Permit Number: 2025001617

Job Description: 098-25 INTERIOR ALTERATIONS -
RESTROOMS

Plan Approval: #098-25
Pine Ridge Country Club
30601 Ridge Road
Wickliffe, Ohio

Occupant Name:	Pine Ridge Country Club/Dino's Catering and Clubhouse	Inspection Date:	4/15/2025
Address:	30601 Ridge Road	Inspection Type:	Plan Review - Building
Structure Name:	Main Building / banquet hall	Inspected By:	James Isom
Suite:

Project 202403	Sheet
Date 12/24	A3
Scale Ceiling Plans

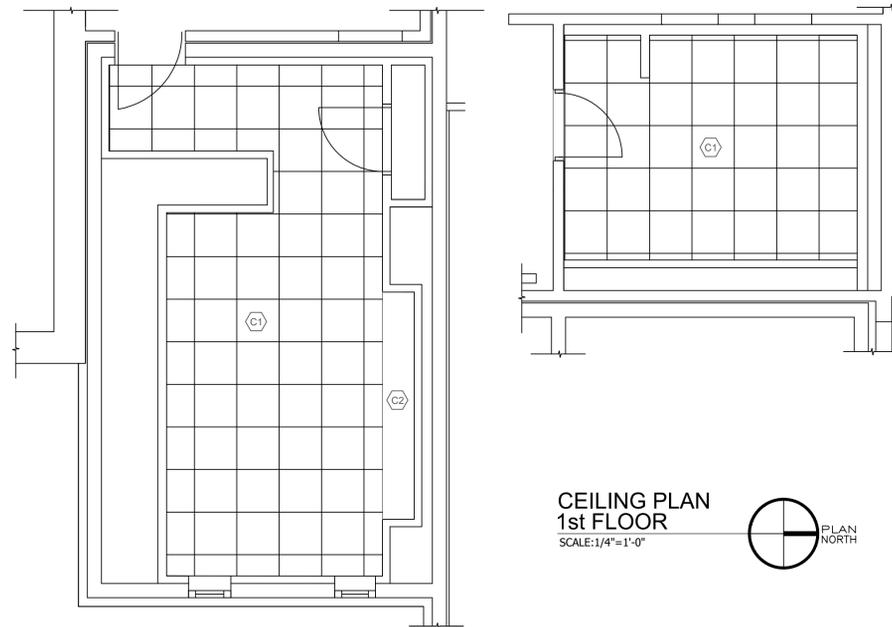
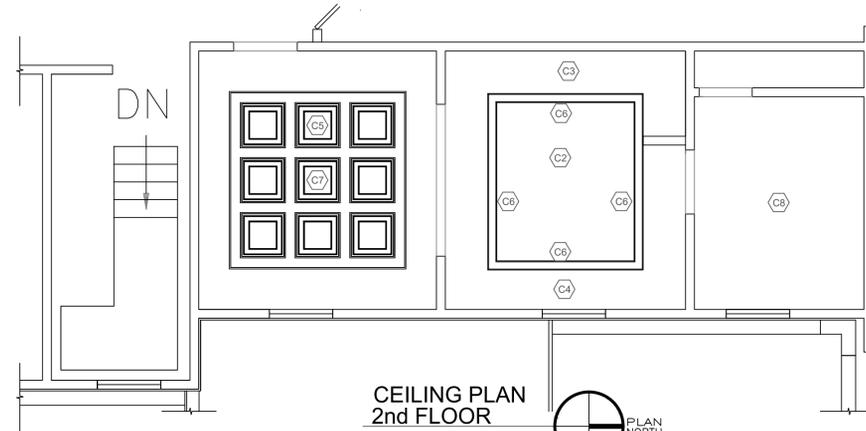
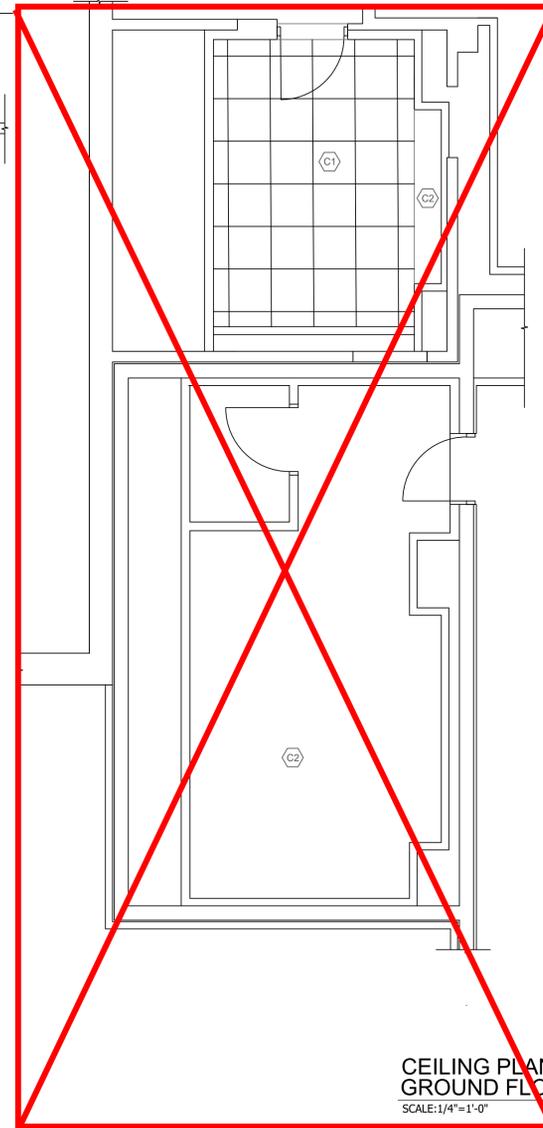
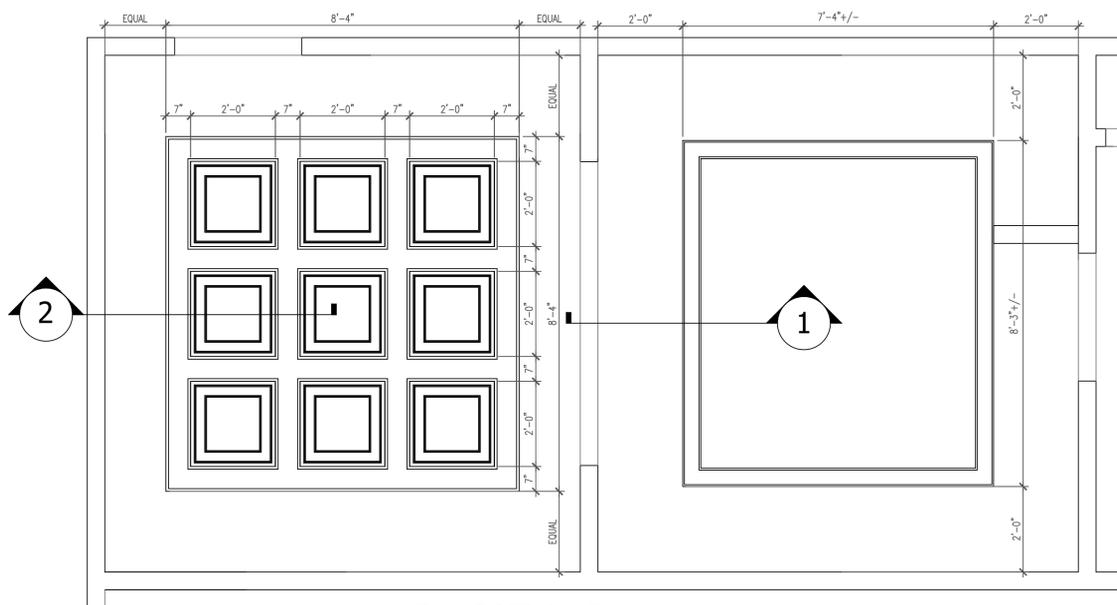
7) Compliance with Interior Finish Requirements for ACT Ceilings verified by review using material data sheet provided by Armstrong World Industries. Classification on plans: Class A. Classification required: Class C - Flame spread index 76—200; smoke-developed index 0—450. See OBC Table 803.13

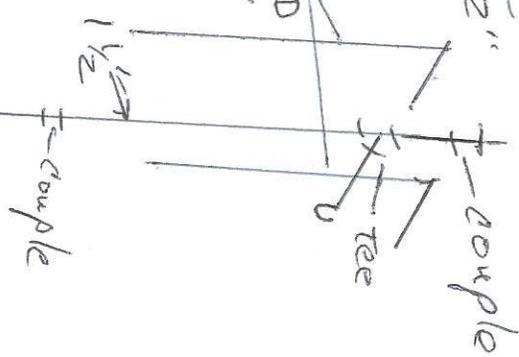
Existing
1/2" HOT + COLD
Supply

Raised new
1/2"

HOT + COLD
Supply

Re-work 7 days
